**AUTHORIZING THE CITY MANAGER TO ENTER INTO A DEVELOPMENT AGREEMENT AND OTHER RELATED AGREEMENTS FOR THE DEVELOPMENT OF THE INDUS BRIDGE STREET DEVELOPMENT WITH INDUS COMPANIES, INC. AND THE DAIMLER GROUP, INC.**

**2. Indus Bridge Street at PIDs: 273-012427, 273-012430, 273-012429, 273-008244, 273-009080, 273-009101 22-172CP**

**Concept Plan**

## **2. Indus Bridge Street at PIDs: 273-012427, 273-012430, 273-012429, 273-008244, 273-009080, 273-009101, 22-172CP, Concept Plan**

SITE PLAN

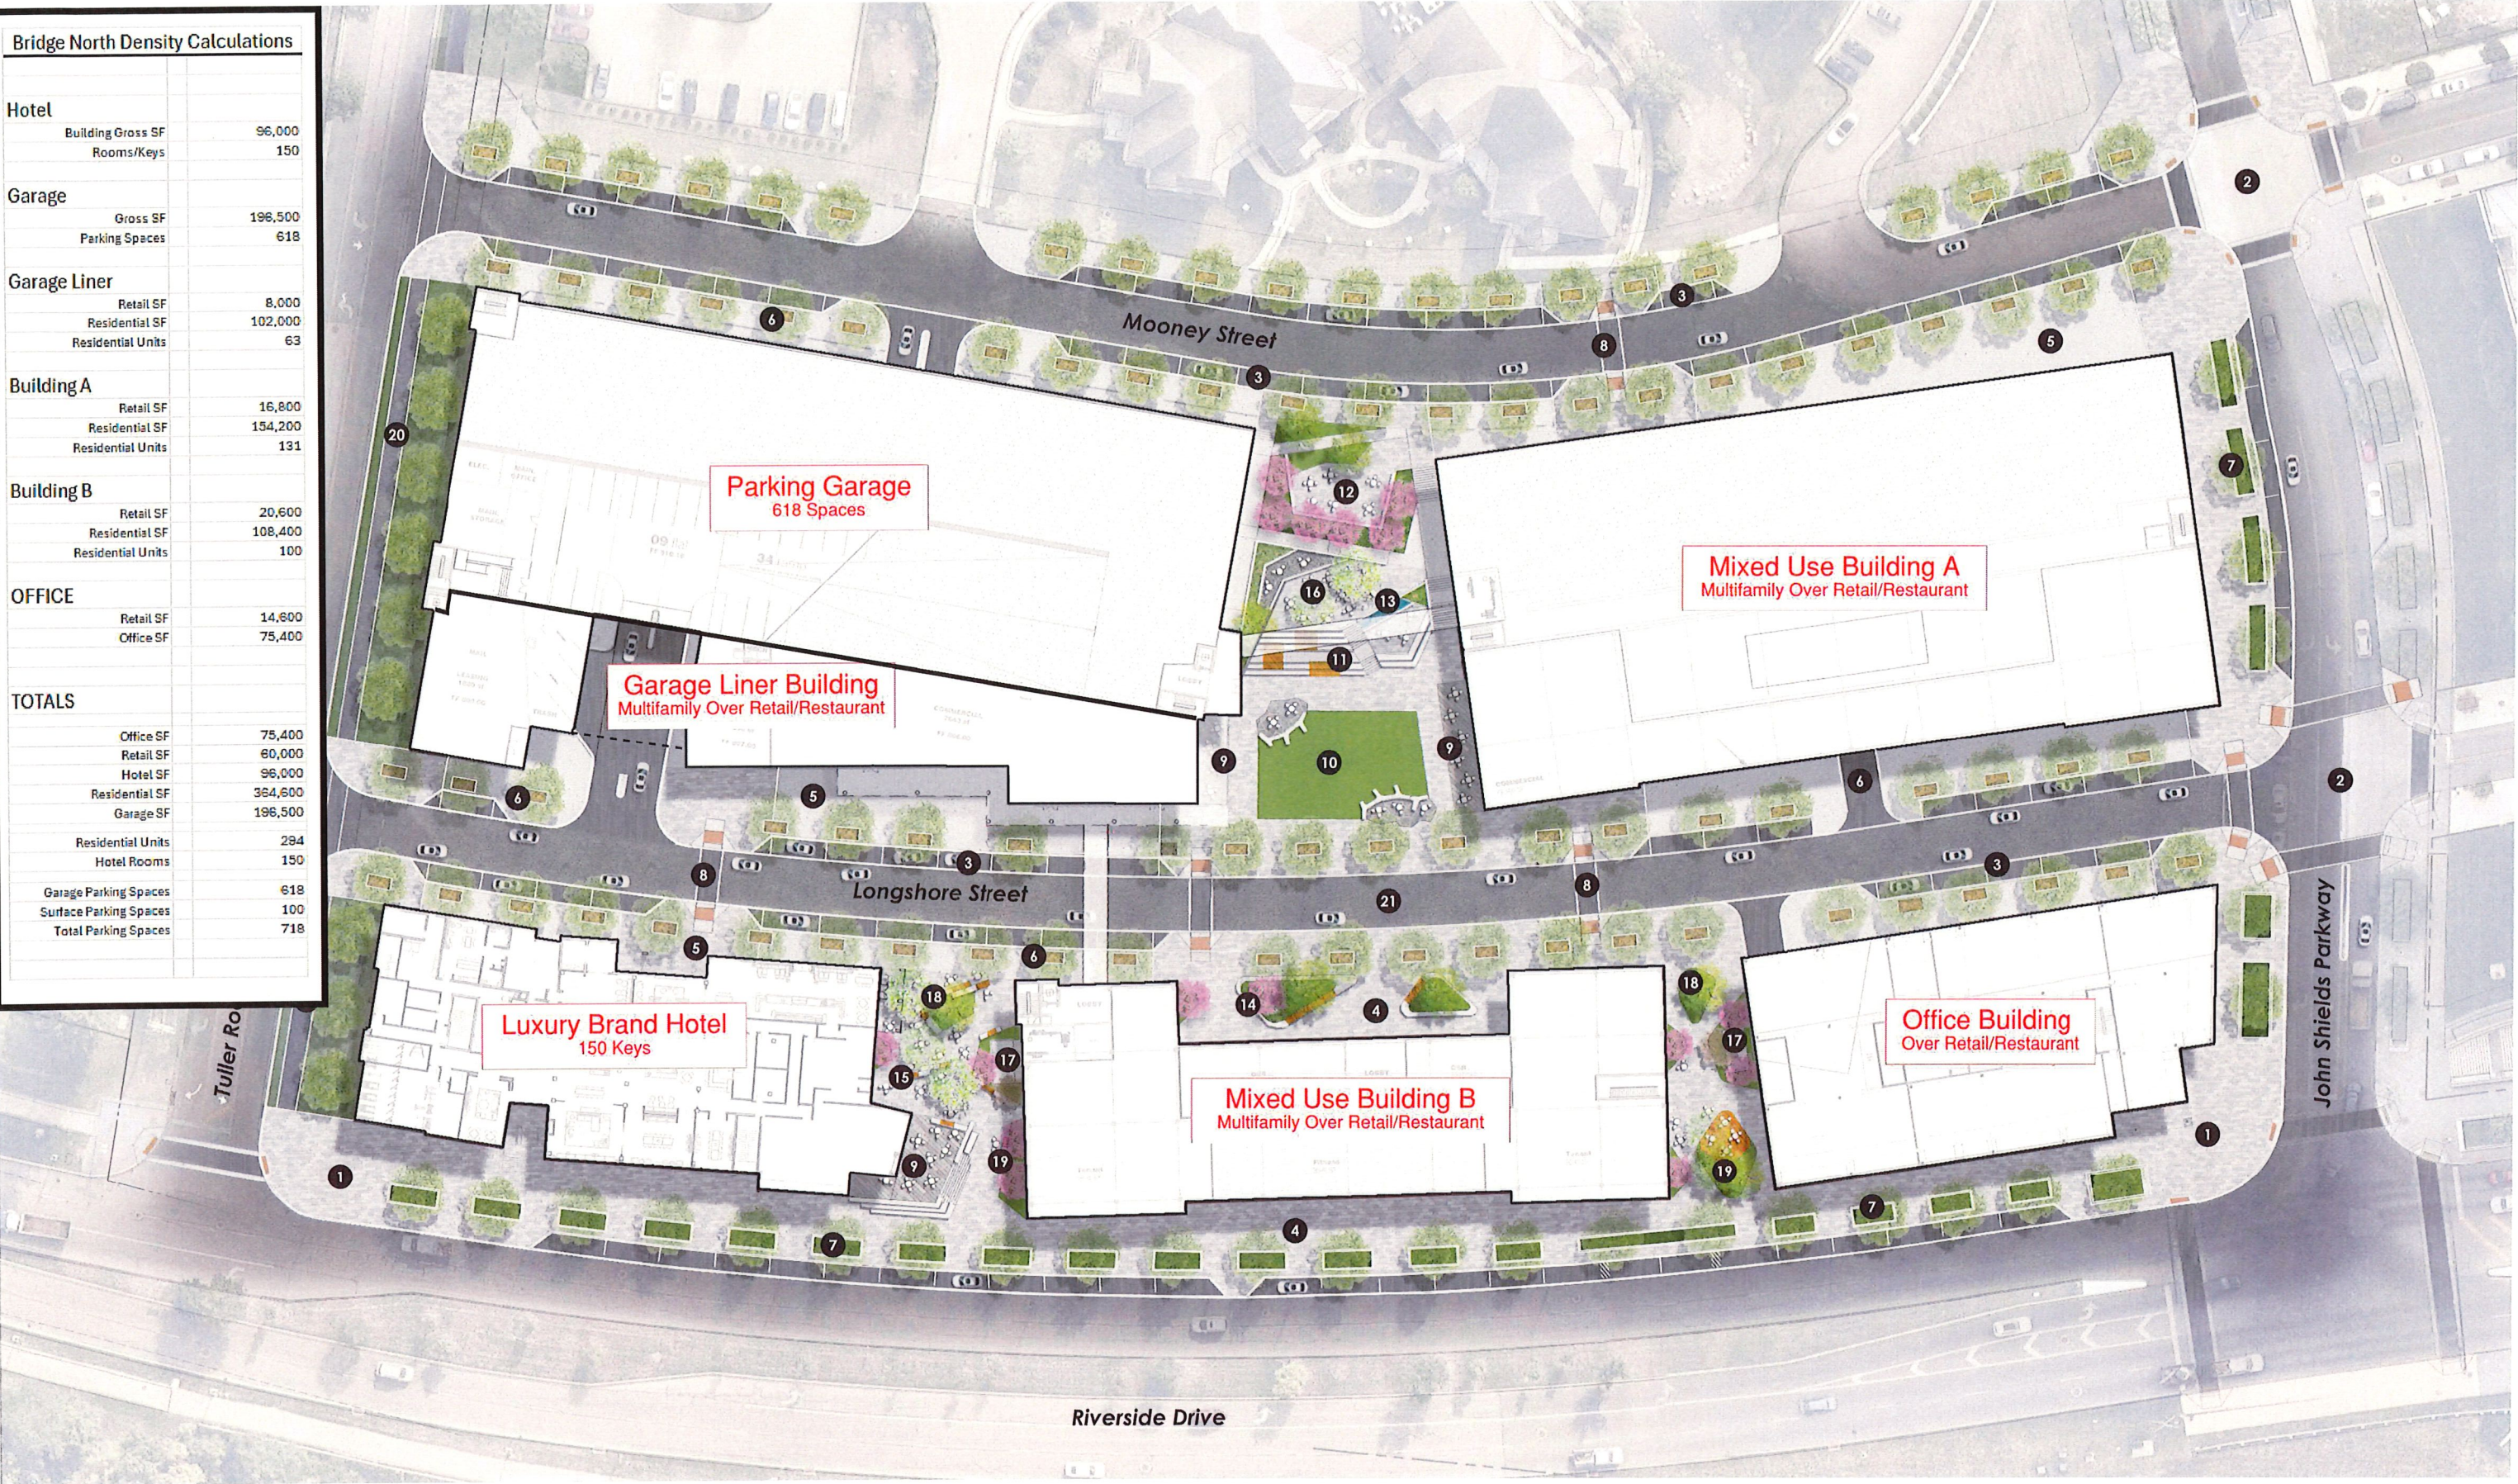
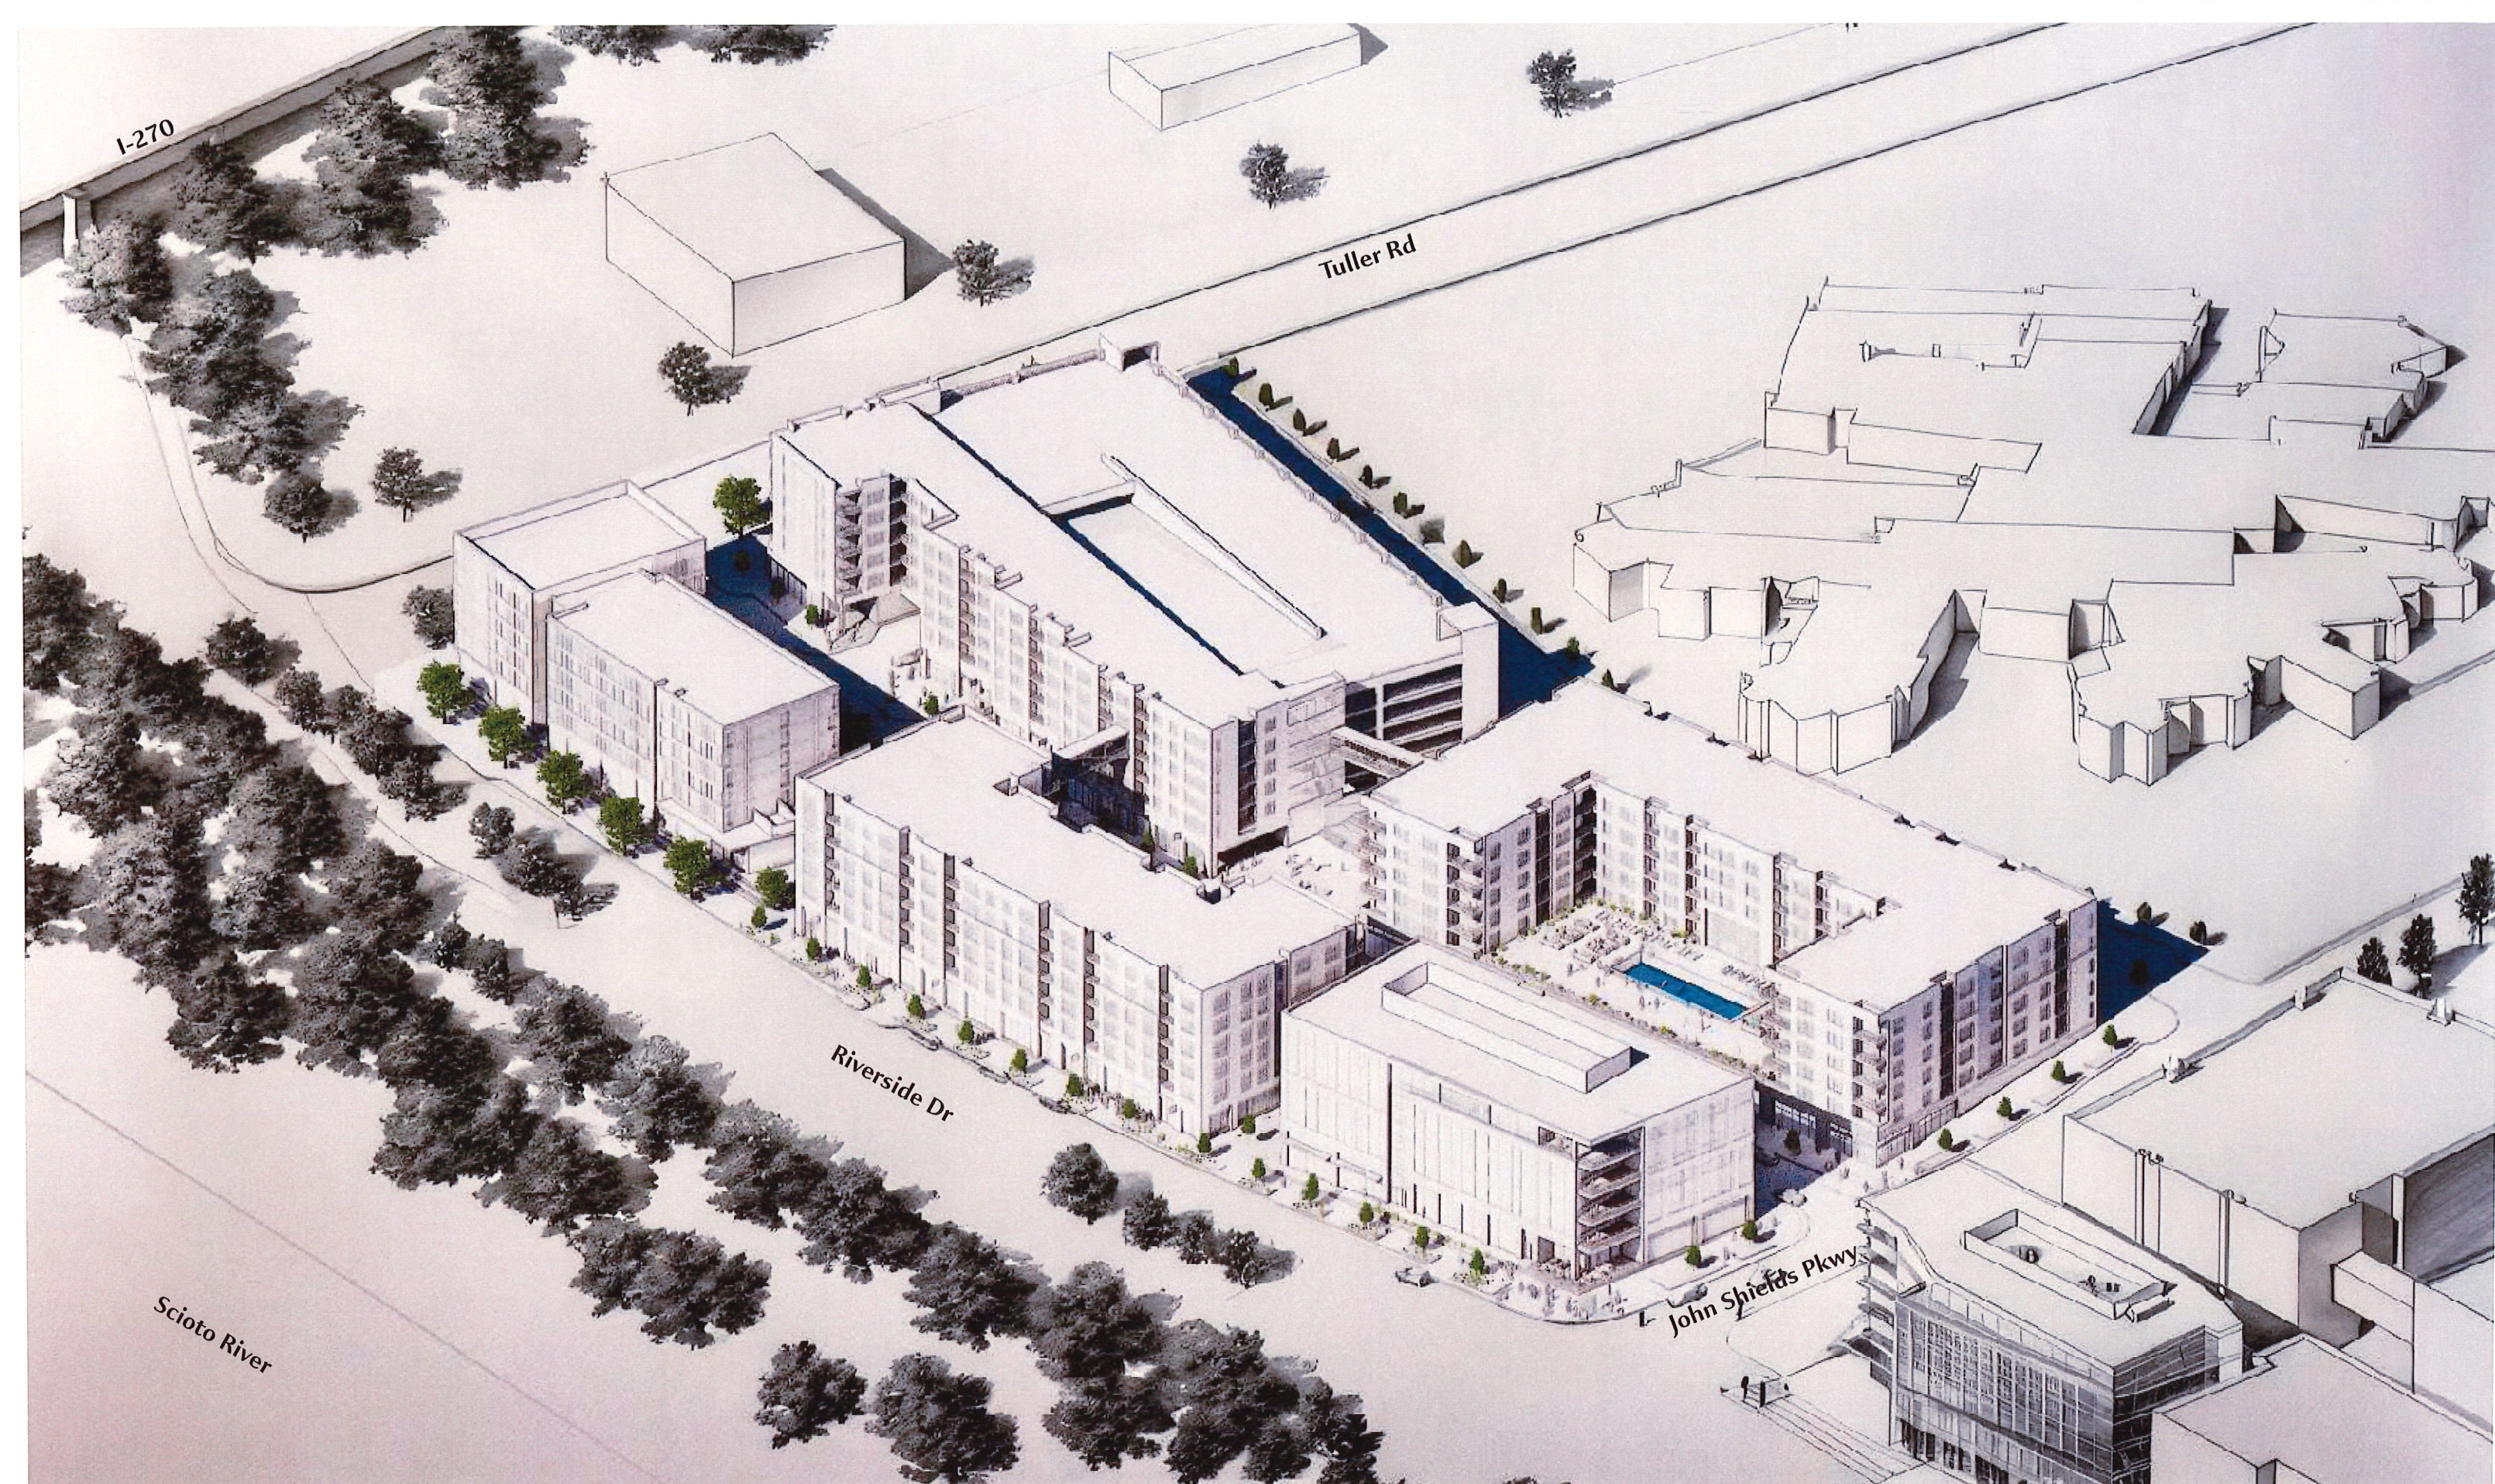
- 1) The applicant consolidate the number of hotel and garage access points and align with the existing access points on the east side of Mooney Street, to the satisfaction of the City Engineer;

- 2) The applicant provide access to the garage from Longshore Street, to the satisfaction of the City Engineer;
- 3) The applicant reduce the massing of the buildings to meet the Code and to complement the existing character of the Scioto River Neighborhood;

- 4) The applicant identify opportunities to reduce the amount of parking spaces and size of the parking structure to meet the Code, which could include investigating shared parking opportunities throughout the Scioto River Neighborhood District;

- 5) The applicant work with staff to provide additional design details with subsequent applications to provide unique gateway designs at the key intersections that align with the requirements of the Scioto River Neighborhood;

- 6) The applicant submit a Traffic Impact Study at a future time determined by staff;
- 7) The applicant continue to work with staff to ensure the heights of the buildings meet the Code and are compatible with the intent and existing buildings of the Scioto River Neighborhood, subject to staff approval;

- 8) The applicant work with staff to ensure unique, high quality architectural design and details are incorporated within the proposed development that complements the district; and
- 9) The applicant identify additional opportunities to activate the north elevation of the garage along Tuller Road.
